Attachment 2
Marked-up Pages

RBS USAR

FIGURE 6.2-61a
PRESSURE IN SHIELD BUILDING
ANNULUS VS TIME
RIVER BEND STATION
UPDATED SAFETY ANALYSIS REPORT

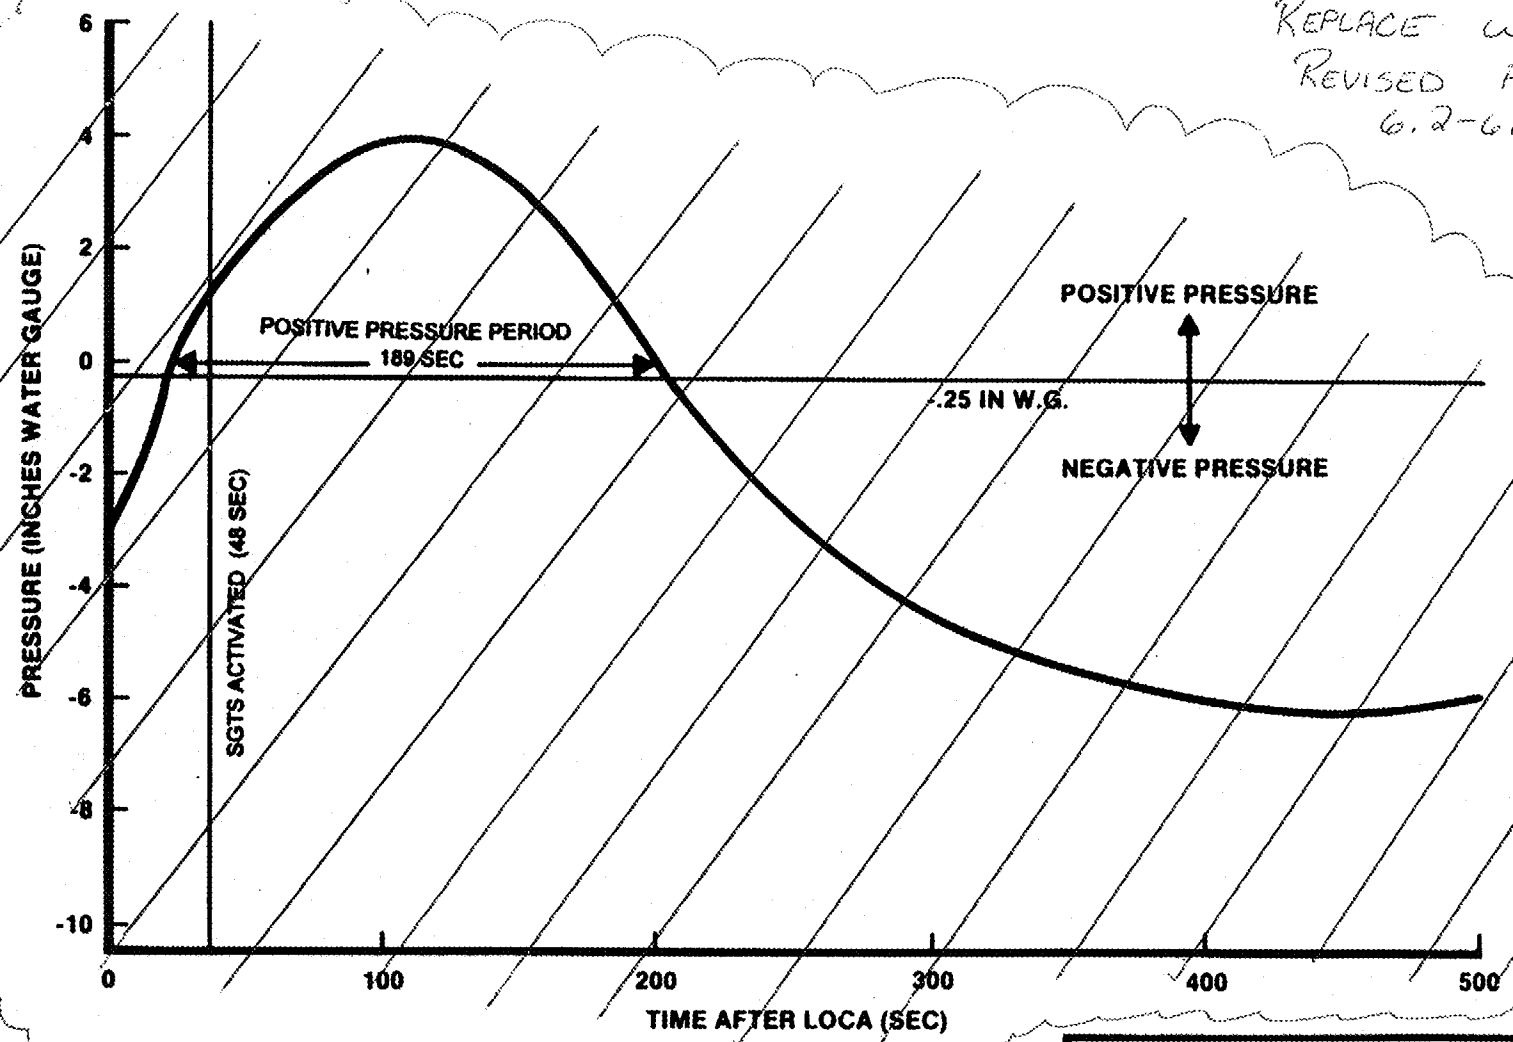
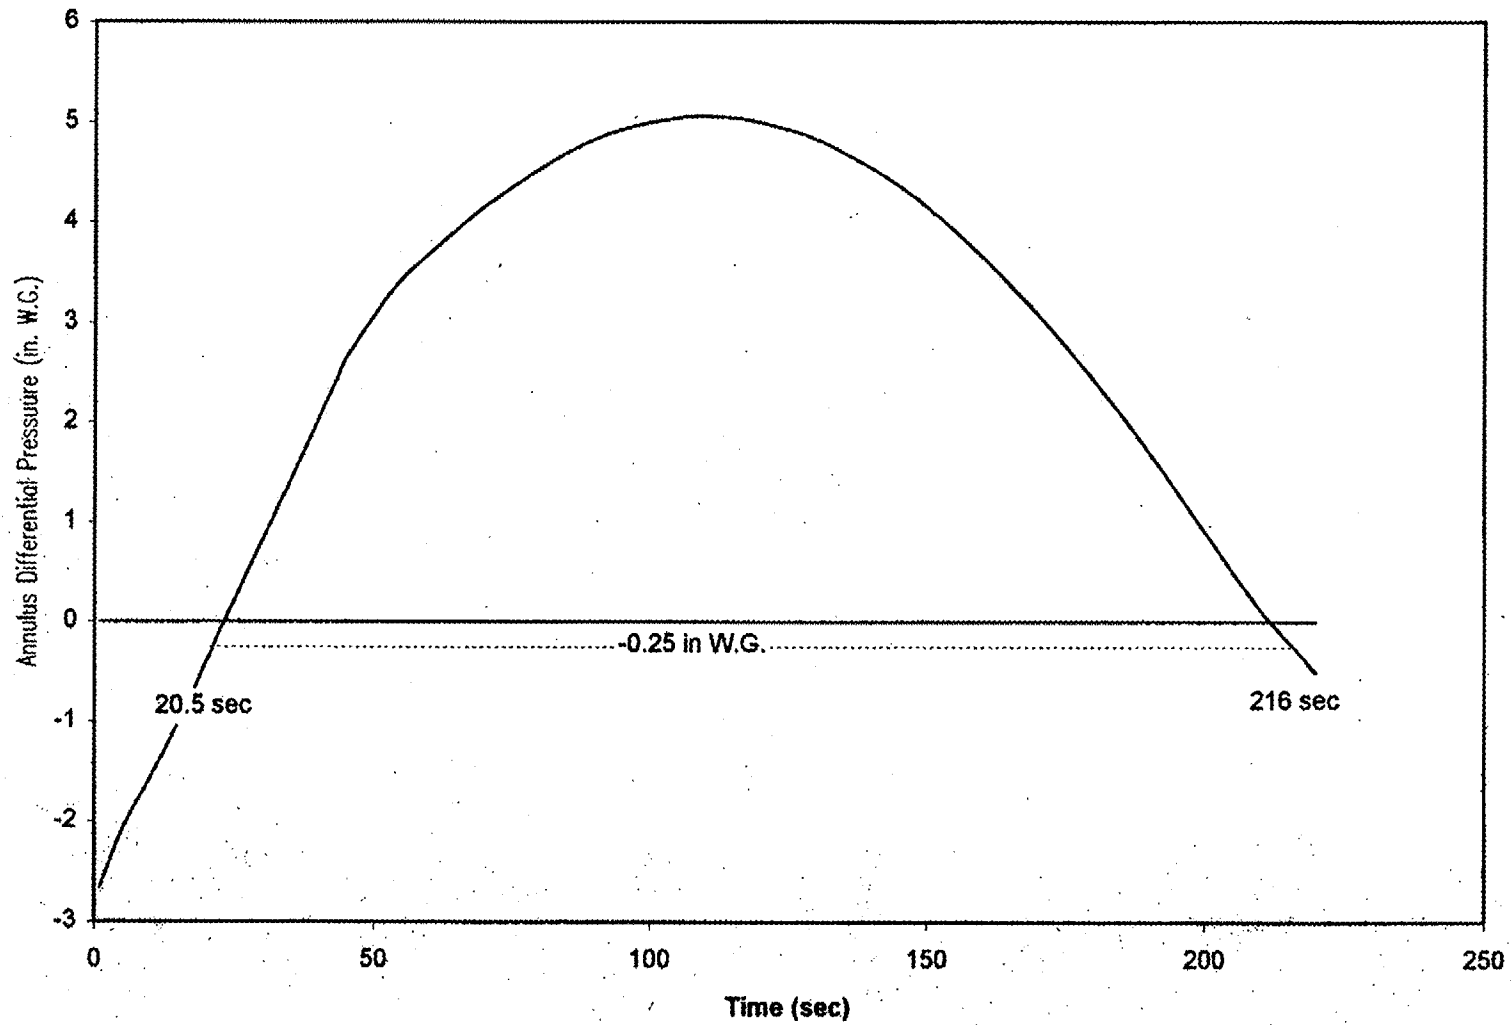
Fig. 6.2-61a indicates that there is a period following a LOCA during which a gauge pressure greater than -0.25 in W.G. exists in the annulus. This period begins approximately 24 sec after the LOCA and lasts for approximately 199 sec. The dose rate analysis during this period indicates that release of contaminated air from the secondary containment is within the limits of 10CFR100.

REPLACE WITH
REVISED FIGURE
6.2-61a

For a period of 20.5 sec following the accident the annulus is below a pressure of -0.25 in W.G. (see Figure 6.2-61a). However, since the auxiliary and fuel buildings exceed -0.25 in W.G., holdup in all of secondary containment is neglected.

REVISED FIGURE 6.2-C19
